BEAVER VALLEY - UNIT 1

ATTACHMENT B  
SAFETY EVALUATION

Proposed Change Request No. 101 amends the Beaver Valley Power Station, Unit No. 1 Technical Specifications, Appendix A surveillance requirement 4.6.1.2a and associated bases 3/4.6.1.2 concerning the Type A test frequency.

FIGURE No. 1 - CILRT CHRONOLOGICAL ILLUSTRATION

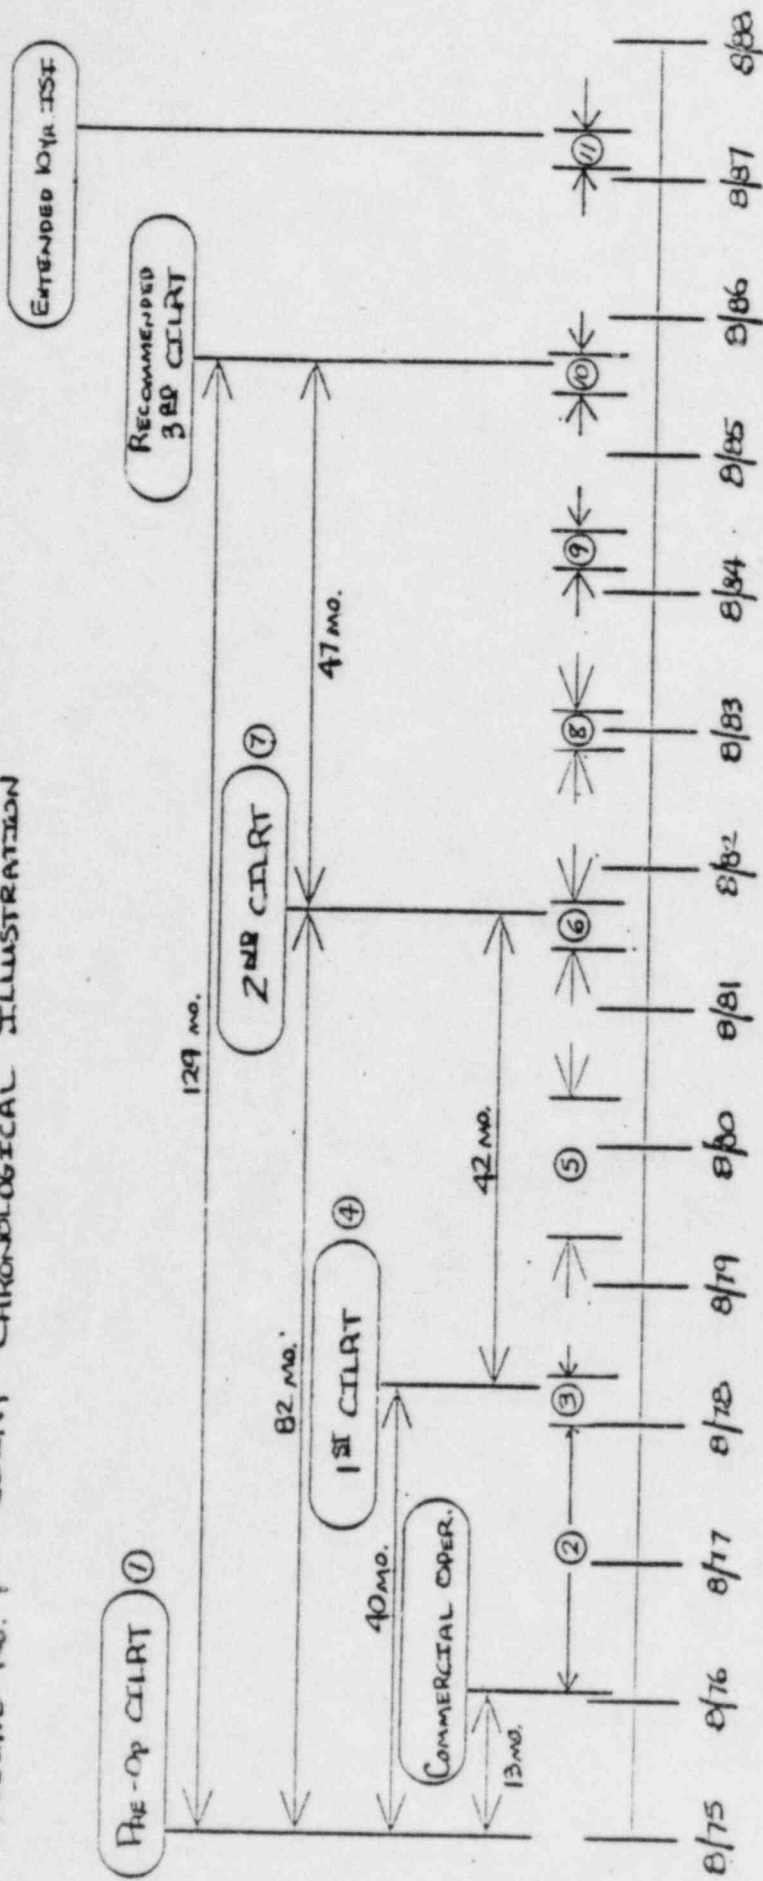
Currently the third Type A Containment Integrated Leak Rate Test (CILRT) is scheduled for the fifth refueling outage (47 months following the second CILRT), see attached Figure 1 (CILRT Chronological Illustration), which provides the past and future outage schedules. The 10-year inservice inspection is scheduled for the sixth refueling outage, therefore, the third CILRT cannot be performed during the shutdown for the 10-year inservice inspection as required by the present Technical Specification requirements.

Surveillance Requirement 4.6.1.2a has been revised to establish a  $40 \pm 10$ -month frequency for the Type A CILRT's. An exemption to 10 CFR 50 Appendix J.III.D.1(a) is also requested, as identified by the note applicable to the above surveillance requirement and specified in the applicable bases. This change and exemption will eliminate the need to perform the third CILRT of each set during the shutdown for the 10-year inservice inspection and will allow more flexibility in the scheduling of CILRT's based on a  $40 \pm 10$ -month frequency.
